FED. ROAD DIST. NO.	STATE	FED. AID PROJ. NO.	FISCAL YEAR	SHEET NO.	TOTAL SHEETS
HAWAII	HAW.	BR-STP-056-1(35)	2000	C.O. 17	70

WAIKAEA BRIDGE WIDENING

KUHIO HIGHWAY-WAIKAEA BRIDGE WIDENING
Fed. Aid Proj. No. BR-STP-056-1(35)

FOUNDATION PLAN
Scale: 1"= 5'-0"

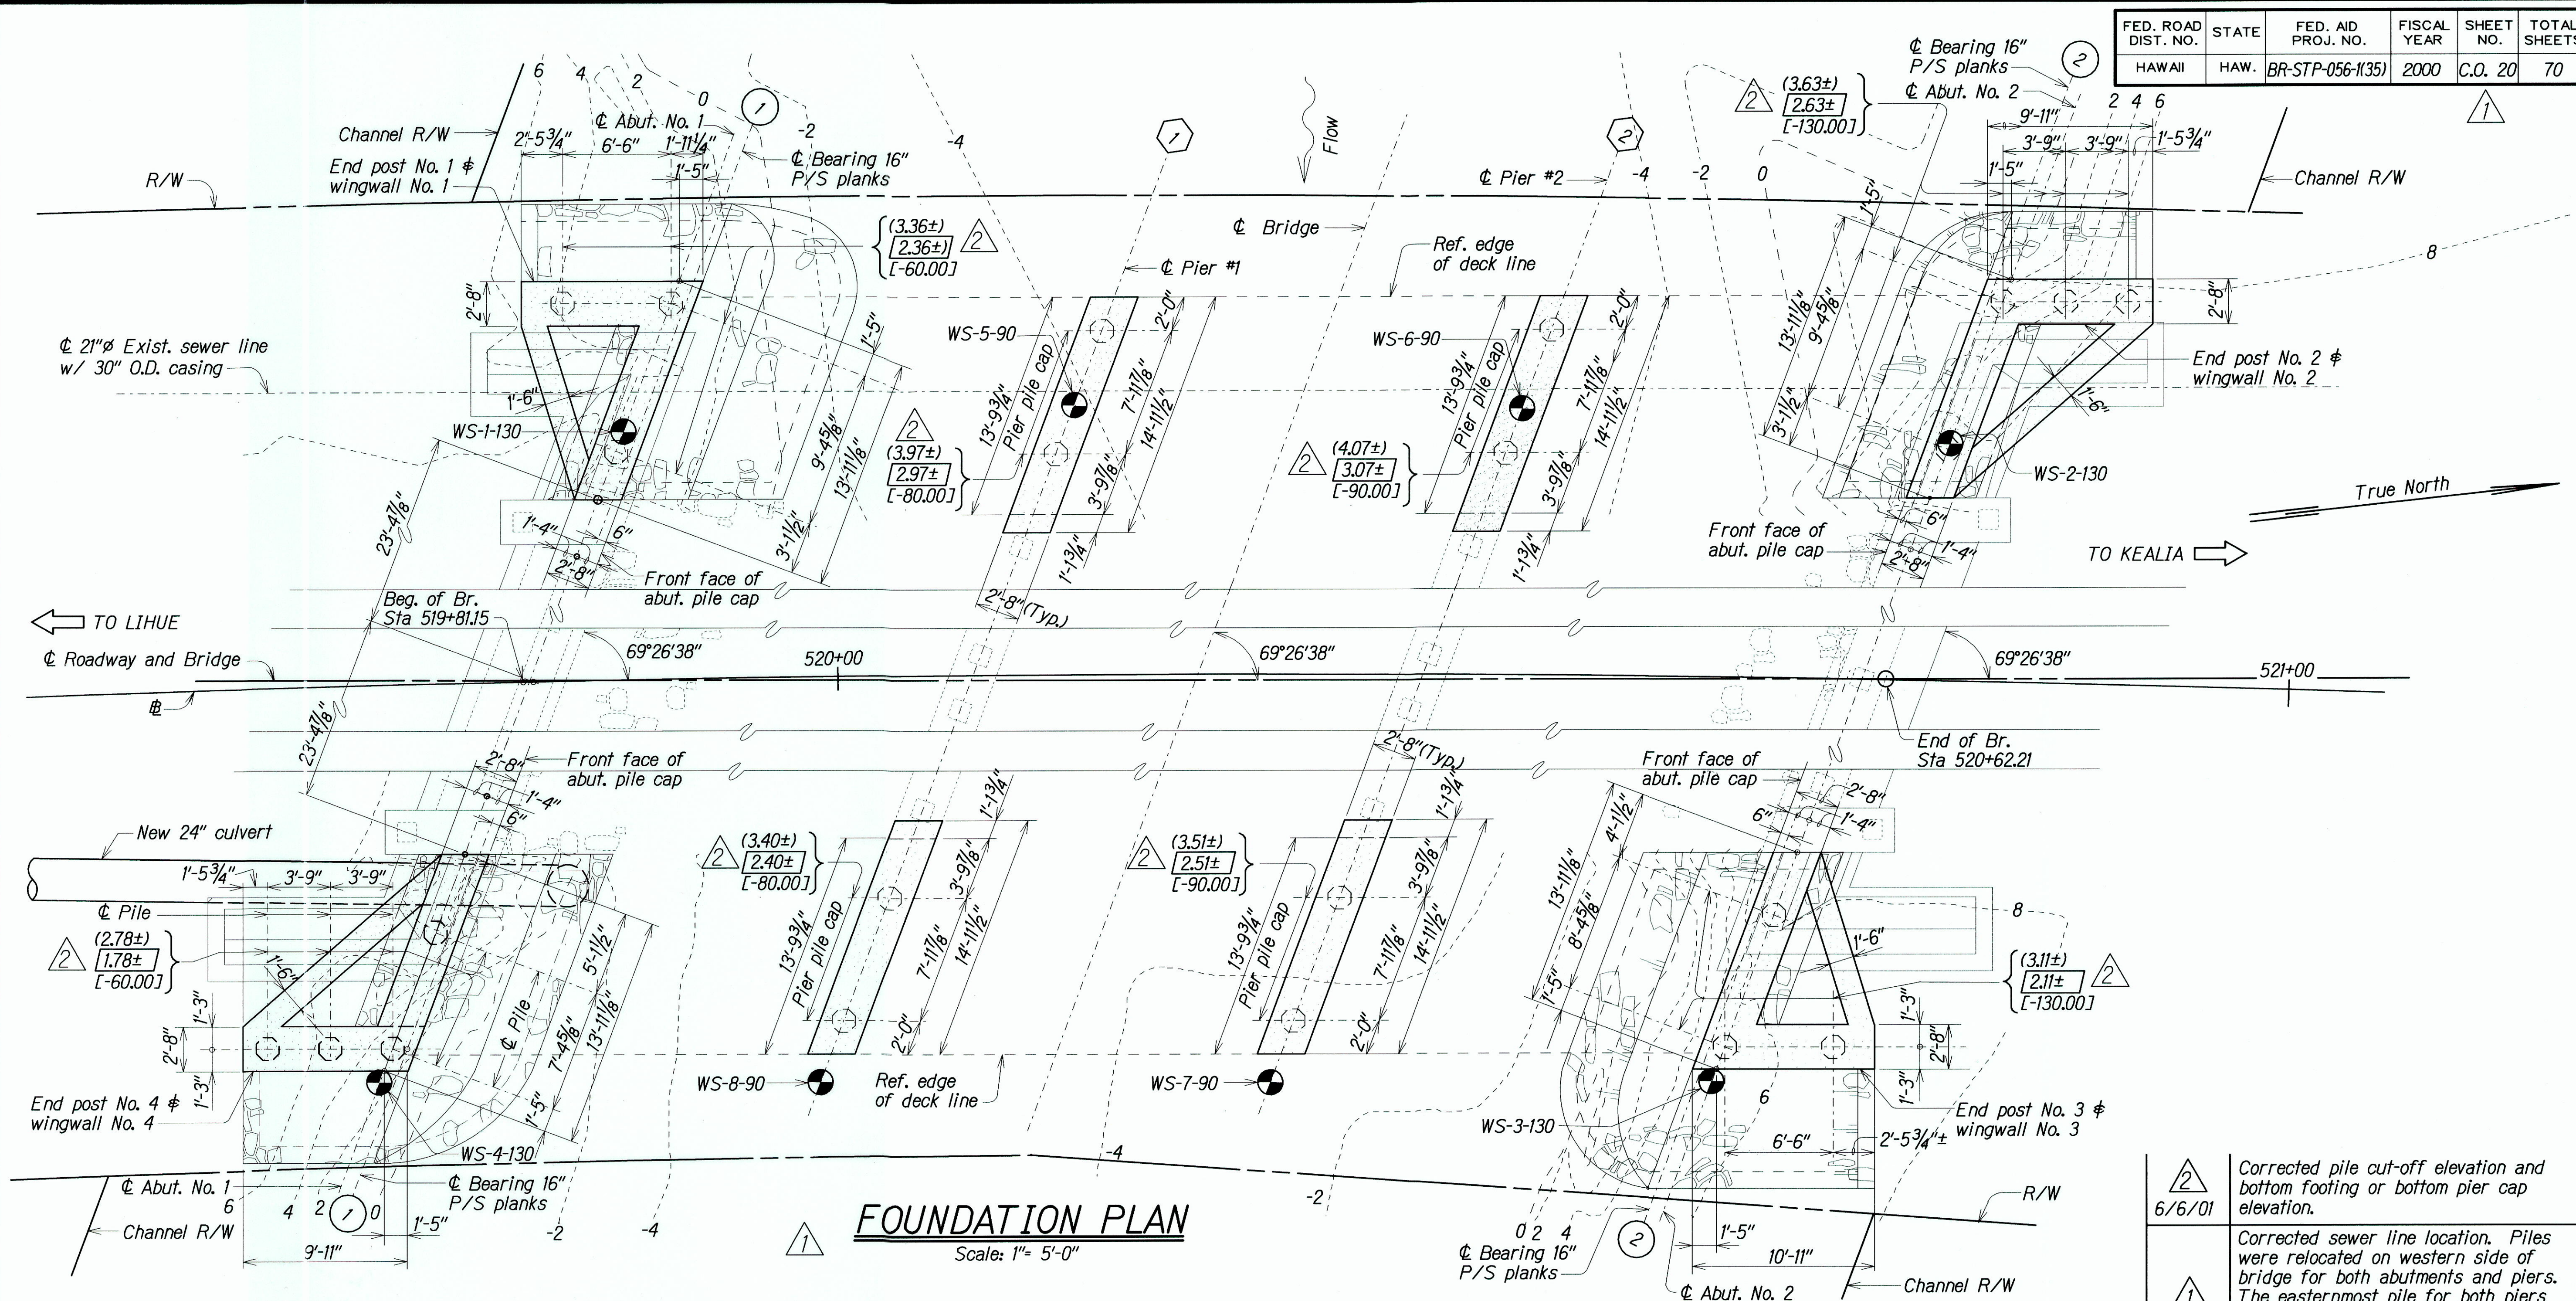
Corrected pile cut-off elevation and bottom footing or bottom pier cap elevation.
	Corrected sewer line location. Piles were relocated on western side of bridge for both abutments and piers. The easternmost pile for both piers on the eastern side of the bridge were relocated. Dimensions were revised to accommodate changes. Dimension lines, labels and patterns were moved or eliminated for clarity.

STATE OF HAWAII DEPARTMENT OF TRANSPORTATION HIGHWAYS DIVISION
WAIKAE A BRIDGE WIDENING ABUTMENT NO. 1 PLAN AND ELEVATION KUHIO HIGHWAY - WAIKAE A BRIDGE WIDENING Fed. Aid Proj. No. BR-STP-056-1(350)
Scale: As Noted Date: Aug. 1999
SHEET No. S9 OF 26 SHEETS

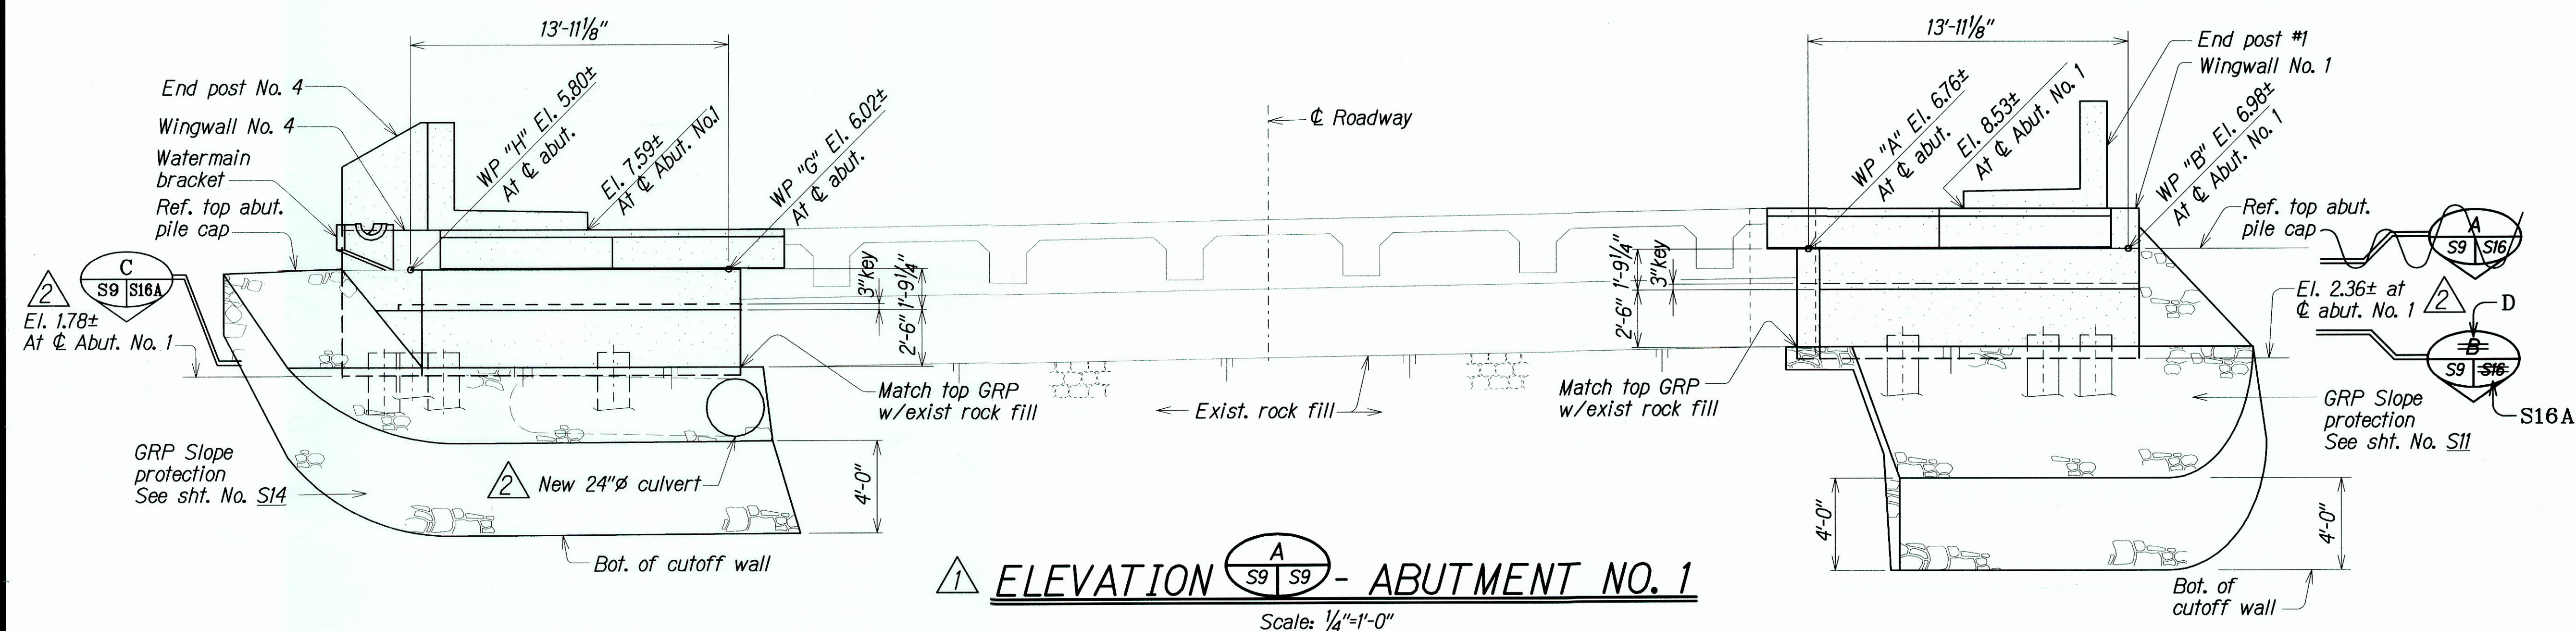
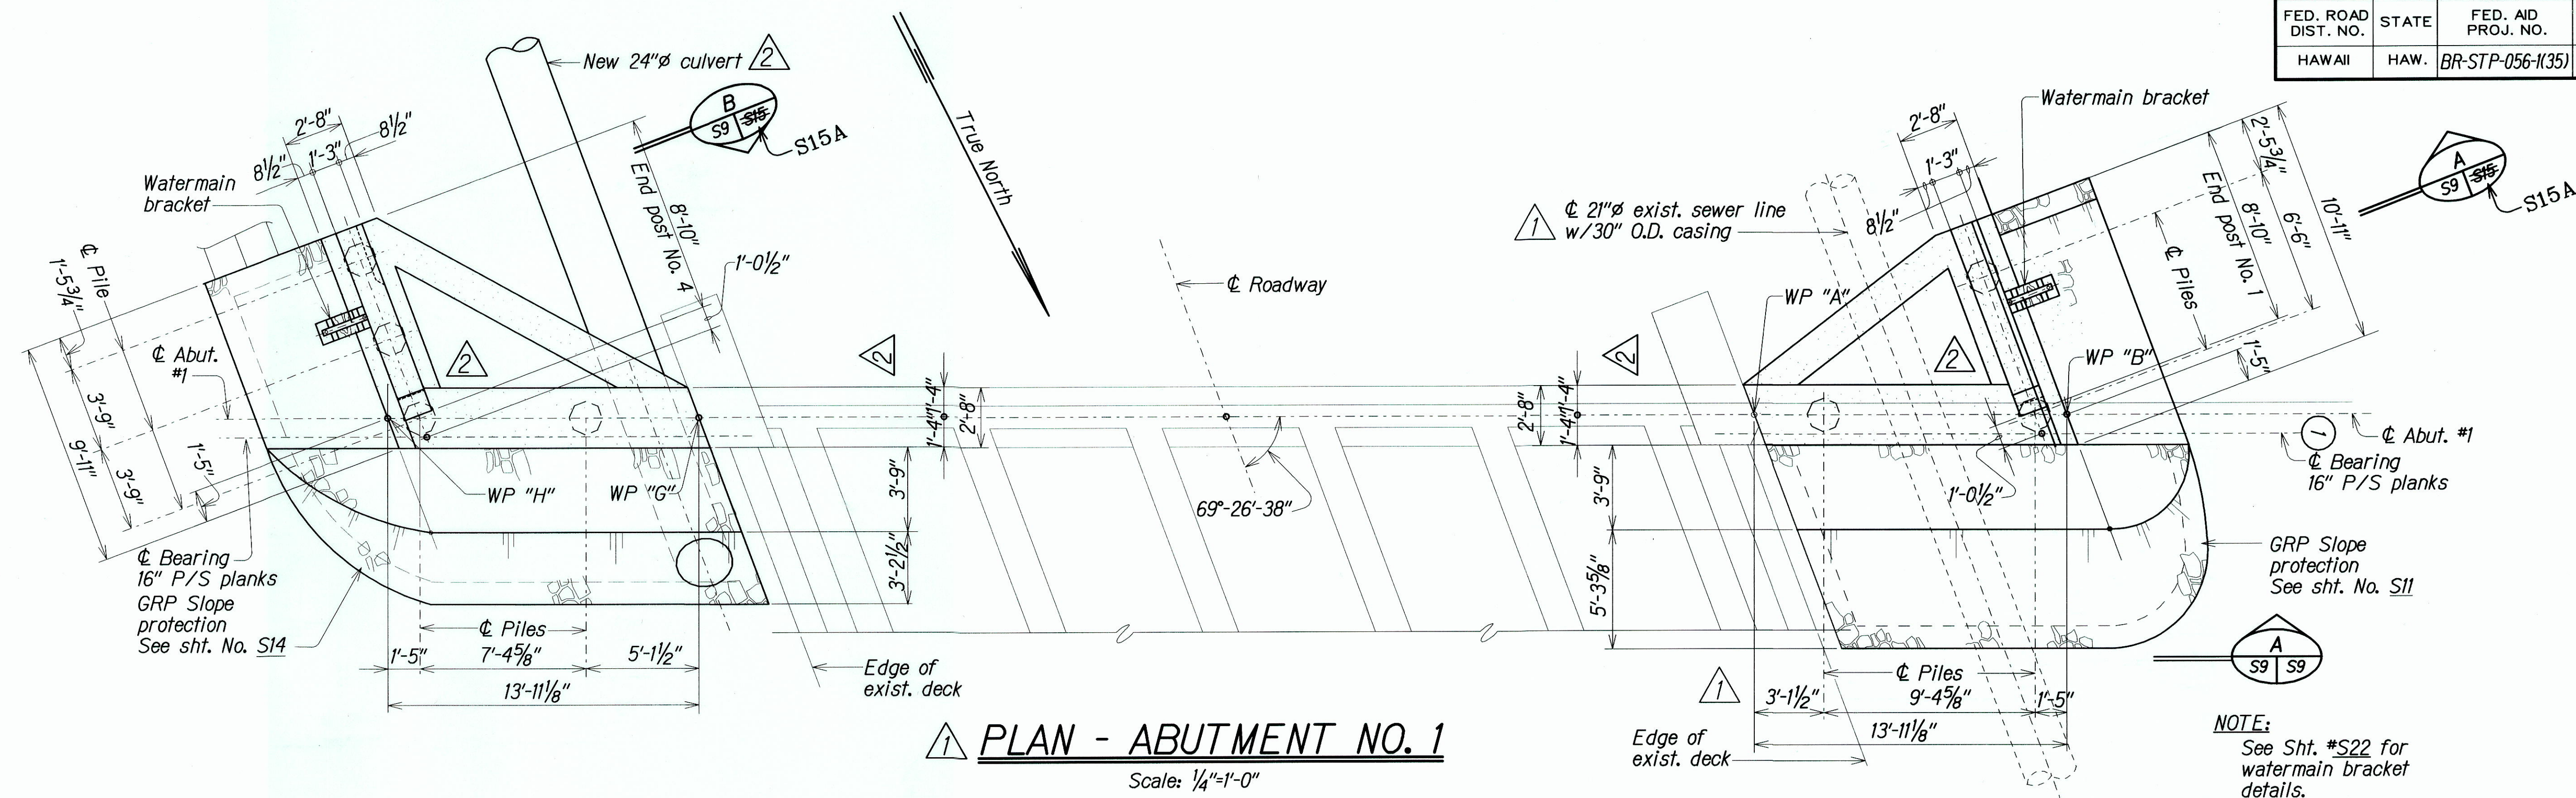
6/6/01	Bottom of abut. pile cap elev. changed for both End Post Nos. 1 & 4. 24"Ø culvert lowered to accommodate elev. change and Ø symbol added to label for 24"Ø culvert. GRP removed behind front face of abut. pile cap. Note #1 added.
3/15/01	Piles were relocated on the western side of the bridge at Abutment No. 1. Dimensions were revised to accommodate changes. Dimension lines, labels and patterns were moved or eliminated for clarity.
DATE	REVISION

STATE OF HAWAII DEPARTMENT OF TRANSPORTATION HIGHWAYS DIVISION	
WAIKAE A BRIDGE WIDENING	
ABUTMENT NO. 2 PLAN AND ELEVATION	
KUHIO HIGHWAY-WAIKAE A BRIDGE WIDENING Fed. Aid Proj. No. BR-STP-056-1(35)	
Scale: As Noted	Date: Aug, 1999
SHEET No. S10 OF 26 SHEETS

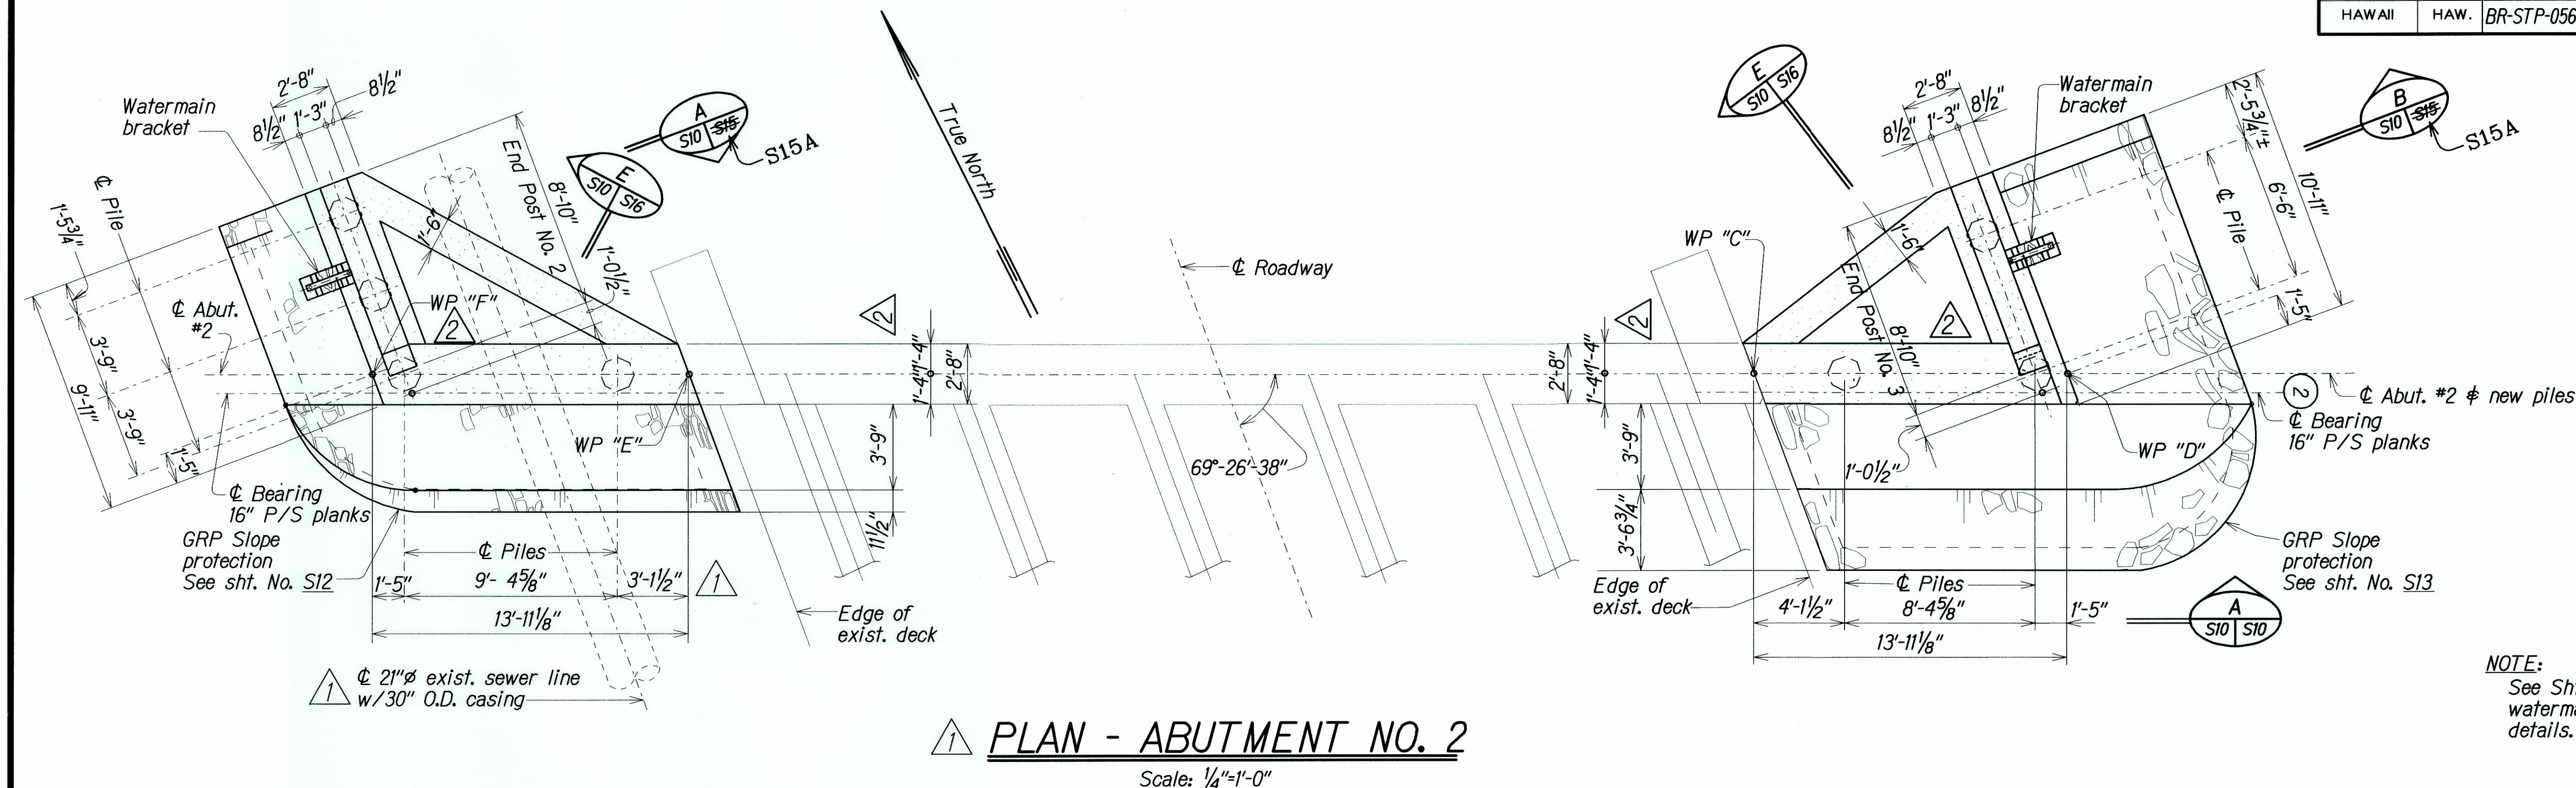
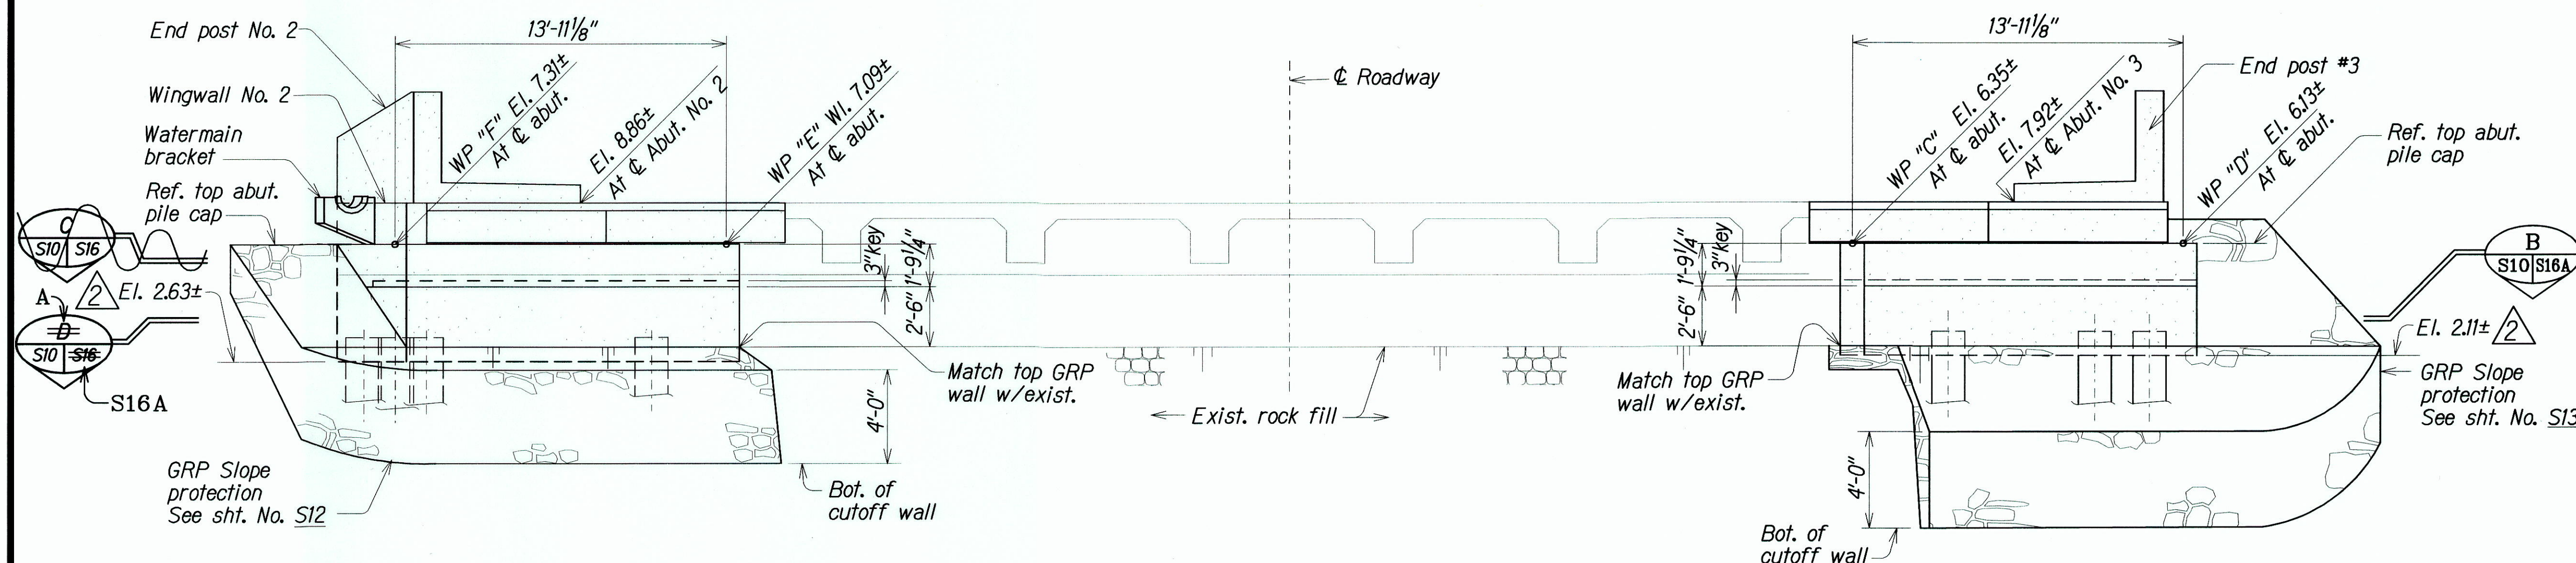
2 6/6/01	Bottom of abut. pile cap elev. changed for both End Post Nos. 2 & 3. Note #1 added. GRP removed behind front face of abut. pile cap.
1 3/15/01	Piles were relocated on the western side of the bridge at Abutment No. 2. Dimensions were revised to accommodate changes. Dimension lines, labels and patterns were moved or eliminated for clarity.
DATE	REVISIONS
